# Product Change Notification

## 113703 - 00

**Change Notification #:** 113703 - 00  
**Change Title:** Intel® Server Rail Kits AXXPRAIL and AXXPRAIL755  
PCN 113703-00, Product Design Upgrade Server Rail Kits  
**Date of Publication:** March 10, 2015

Location of Rails

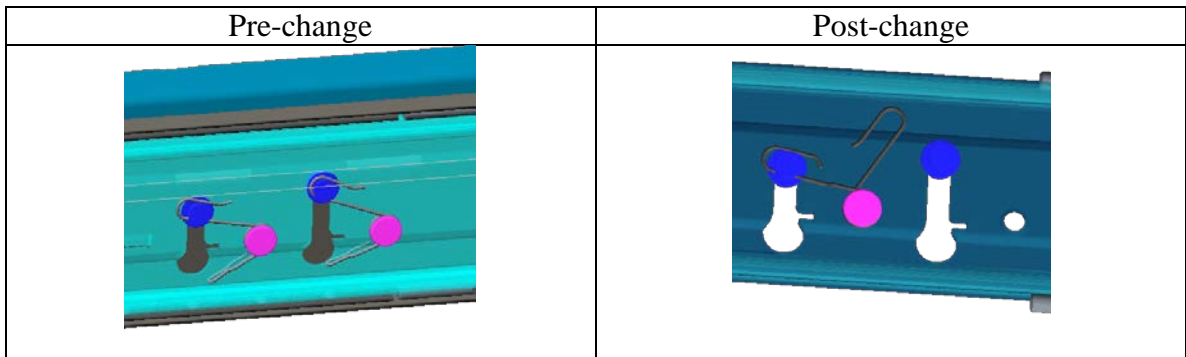
Upgrade the AXXPRAIL and AXXPRAIL755 to improve the stability of the aluminum guide blocks and assembly flexibility.

1. Update the Guide blocks.

Location of slots. Increase the J slot cutouts to help eliminate burrs during stamping process.

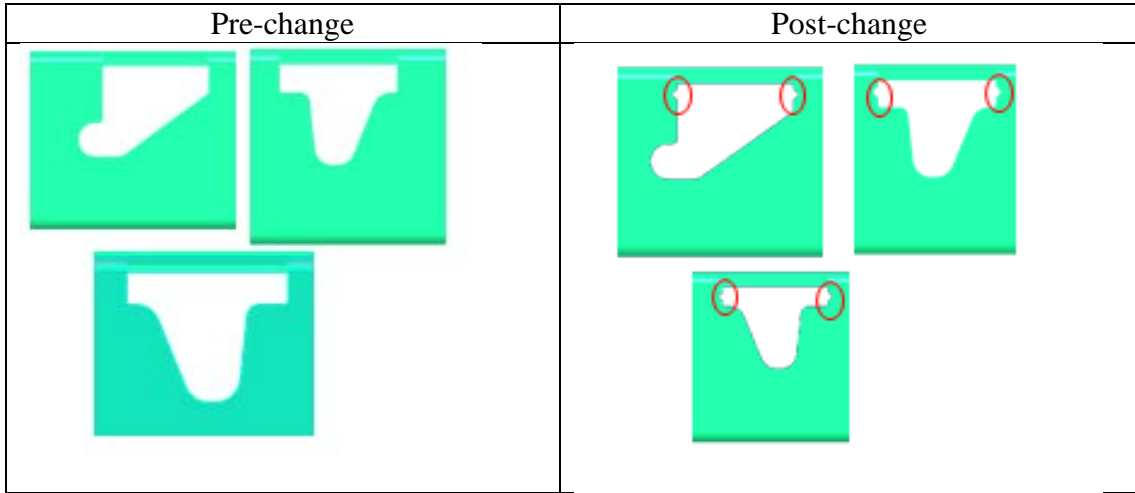
2. Update the Stage lock.

3. Update the inner member.
